TECHNICAL SERVICE BULLETIN

SUBJECT: REAR HATCH (LIFT GATE) NOISE			No: TSB-01-42A-010
			DATE: August, 2001
			MODEL: 1997-2002 Montero Sport
CIRCULATE TO:	<input type="checkbox"/> GENERAL MANAGER	<input type="checkbox"/> PARTS MANAGER	<input checked="" type="checkbox"/> TECHNICIAN
<input checked="" type="checkbox"/> SERVICE ADVISOR	<input checked="" type="checkbox"/> SERVICE MANAGER	<input checked="" type="checkbox"/> WARRANTY PROCESSOR	<input type="checkbox"/> SALES MANAGER

The bulletin contains instructions for eliminating a popping noise from the rear hatch area of the vehicle.

2. Lift Gate Damper Adjustment:

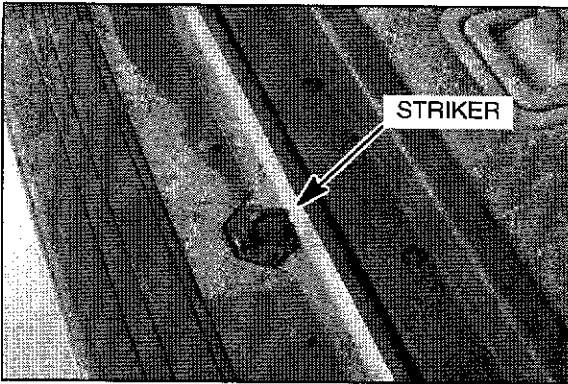
Loosen the lift gate (hatch) damper bolts on both sides. Rotate each damper so it rests on the "C"-shaped bracket when the hatch is closed. The dampers can be rotated either upward or downward, so they will have good contact with the brackets.

The damper and "C" bracket contact can be viewed through the body seam when the rear hatch is closed.
